Working document on possible ecodesign and energy labelling requirements for room air conditioning appliances, local air coolers and comfort fans.

Comments in preparation of the consultation forum of 22 June 2009

Brussels, 24 August 2009

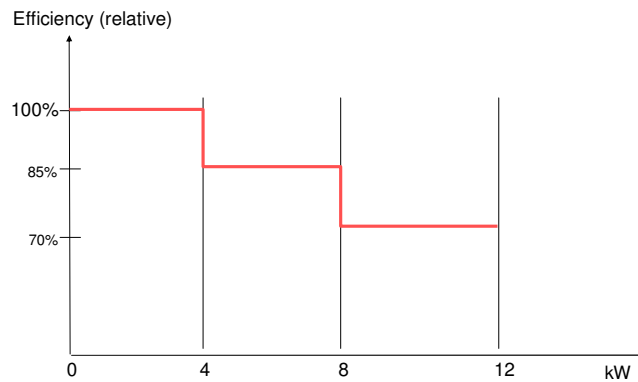
The minimum efficiency requirements specified in this working document are even more ambitious than the proposed measures in task 8 of the preparatory studies. Please explain about the data and your conclusions from this data that led to the increase of “Minimum energy efficiency performance requirements”.

The present minimum requirements are based on energy use reduction scenarios that do not take into account the fact that heatpump technology has a beneficial effect on primary energy use and CO₂-reductions, in replacing conventional and electric heating systems. This is not well reflected and explained in the study, and now is also neglected in setting minimum efficiency requirements.

Appliances with higher capacity classes are restricted in improving energy efficiency due to building constraints. As such the measures should incorporate these differences in the implementing measure. Japanese Law is set up to consider these technical differences, and should be taken as an example to set up minimum efficiency requirements. In general, a difference in efficiency of 15% should be considered for each capacity step.

We propose to apply the following scenario:

This results in following minimum efficiency requirements:

0-4kW	4-8kW	8-12kW
SEER	3 years	3.6	3.1	2.6
	8 years	4.3	3.7	3.1
SCOP	3 years	3.2	2.7	2.3
	8 years	3.5	3.0	2.5

3. The timing between the implementing measures should be increased.

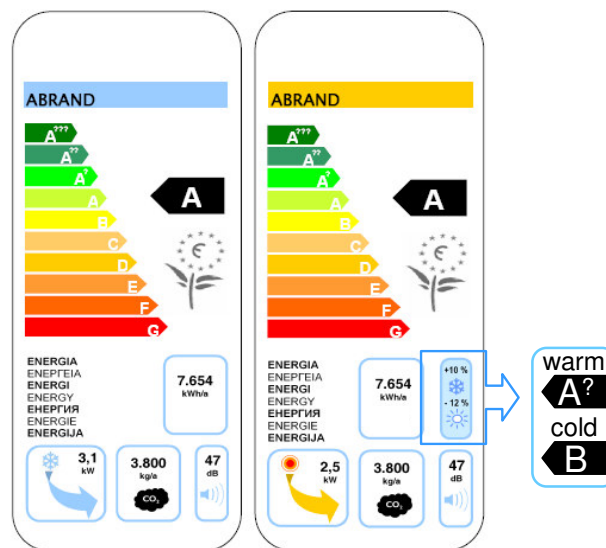
2 years is not considering the redesign-cycles of the appliances, and do not allow the market to settle on the improvements.

Our proposal is to foresee at least 5 years inbetween measure, in line with the re-design cycles stated in the task 8 report.
